**Amendments to the Drawings:**

This is response to the Office Action dated March 19, 2007.

Appl. No. 10/525,932  
 Amdt. Dated June 19, 2007  
 Reply to Office Action of March 19, 2007  
 Annotated Sheet Showing Changes

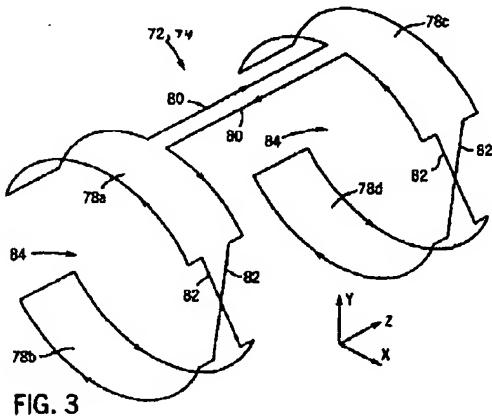
In the Office Action, the Examiner identified elements 78c, 78d or 78a, 78b of Boskamp as satisfying the limitation of applicants' independent Claims 1 and 7 that calls for a "pair of main conductors extending generally parallel to the direction of the magnetic field and located on opposite sides of the space." See paragraphs 8 and 14 of the Office Action. The following is a copy of Figure 3 of Boskamp:

As can be seen from the X-Y-Z coordinate system shown in this figure, conductors 78a, 78b, 78c, and 78d are all parallel to Boskamp's X-Y plane, i.e., perpendicular to Boskamp's Z-axis. Boskamp's magnetic field, however, is along the Z-axis:

Accordingly, conductors 78a, 78b, 78c, and 78d do not "extending generally parallel to the direction of the magnetic field," but are perpendicular to that direction. It is thus clear that Boskamp does not disclose or suggest the subject matter of independent Claims 1 and 7.

FIG 9A

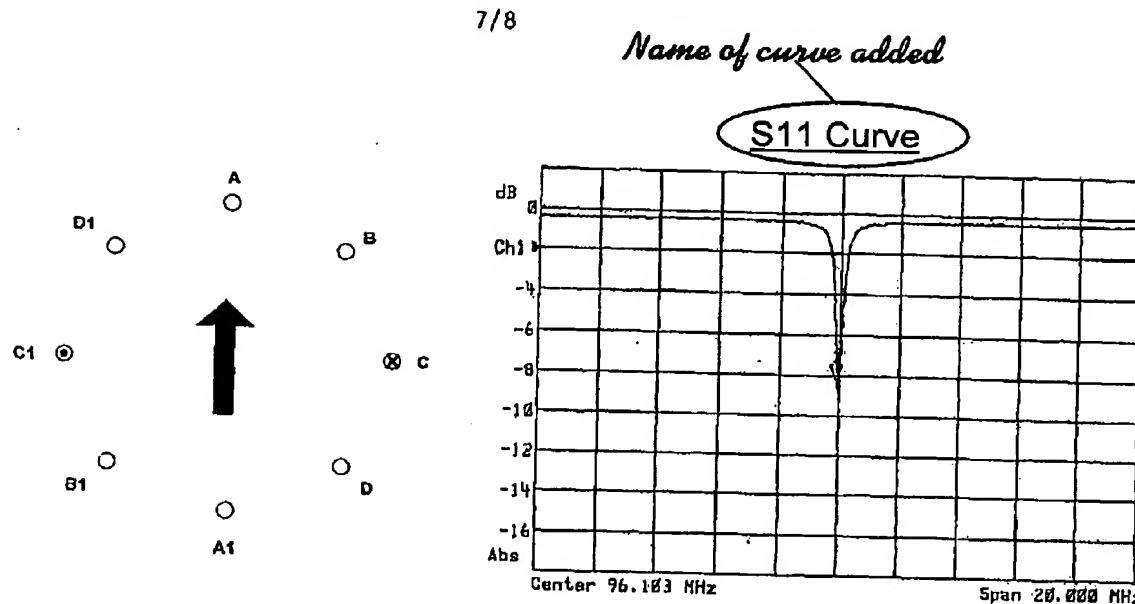
The attached sheets of drawings include changes to Figures 9A, 9B, 9C, and 9D. These sheets, which include just these figures, replace the original sheets, which also included just these figures.

In each of Figures 9A, 9B, 9C, and 9D, the graph on the right hand side of the figure has been identified as a "S11 Curve." No new matter is added by this change since this is the same terminology that was used to describe Figure 9 in the Brief Description of the Drawings (see page 5, line 4, of applicants' specification).

By the above amendment, applicants have added the designation "S11 Curve" to each of Figures 9A, 9B, 9C, and 9D. As discussed in applicants prior response, the S11 curves are not a "component" of applicants' coil arrays but relate to the performance of those arrays. The inclusion of the "S11 Curve" designation in each of Figures 9A, 9B, 9C, and 9D is believed to address the Examiner's request that there be a literal reference to the S11 curves in applicants' figures.
